Subject: Fuel Tank Fuel Gage Improvement      Bulletin Type: Field Fix Mandatory

Bulletin No: TS35-FC-2104

Vehicle Model: TS35

This bulletin aims to improve the fuel tank gage of the fuel tank.

Figure 5 and 6

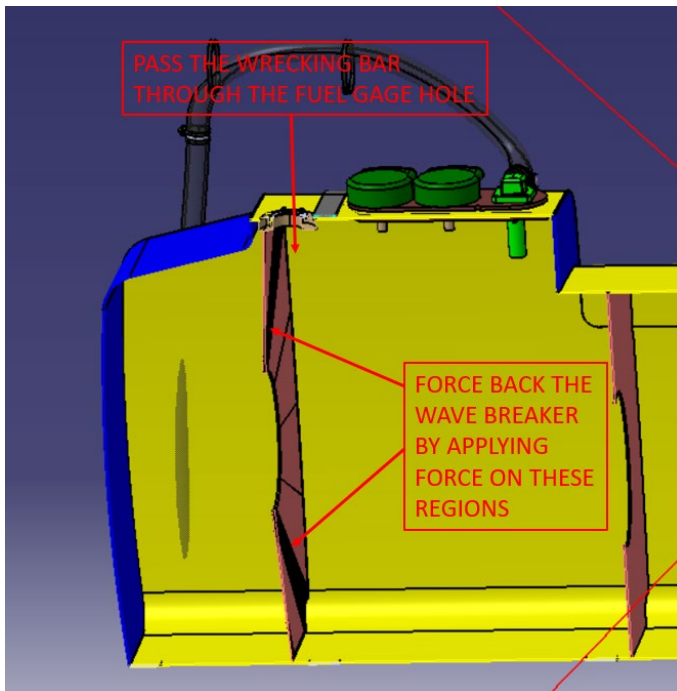
5. Use the wrecking bar to force back the wave breaker in order to increase the space between the wave breaker and the fuel gage. (See Figure-5 and Figure-6)

Figure-7

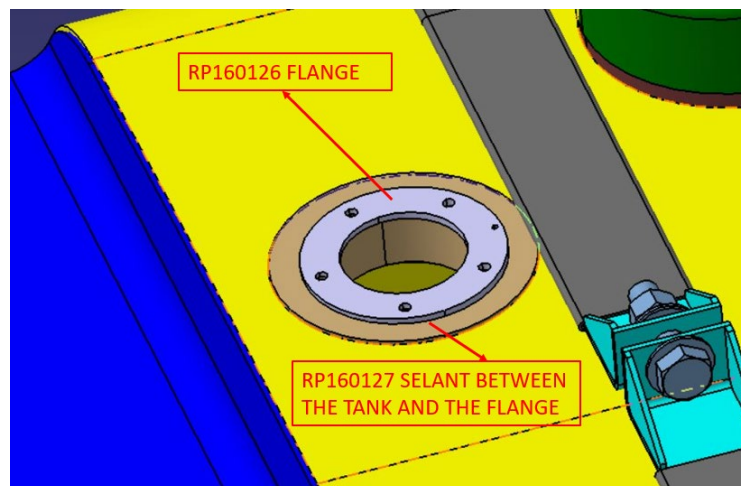
6. Insert the fuel tank flange above the sealer. Make sure that the small hole points the exact opposite of the fuel tank fill neck. (See Figure-7)

**Figure-8 and 9**

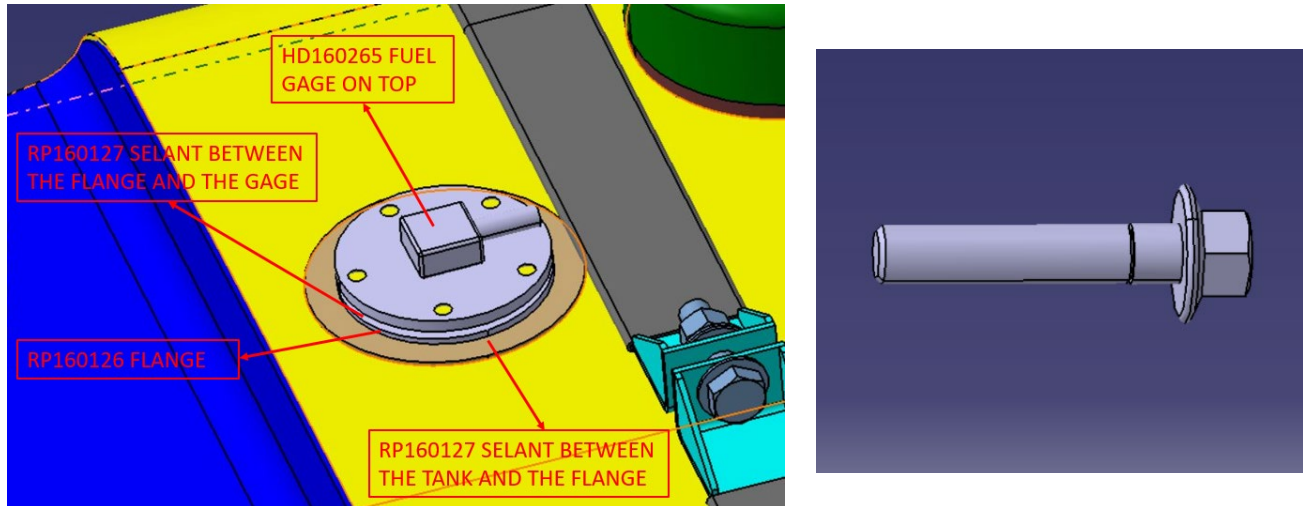
- Put the extra sealer above the fuel tank flange and place the sealer above it and place the fuel gage on top of them. Then assemble the new 5 pieces of M5x0.8x0 screws. **(See Figure-8 and 9)**
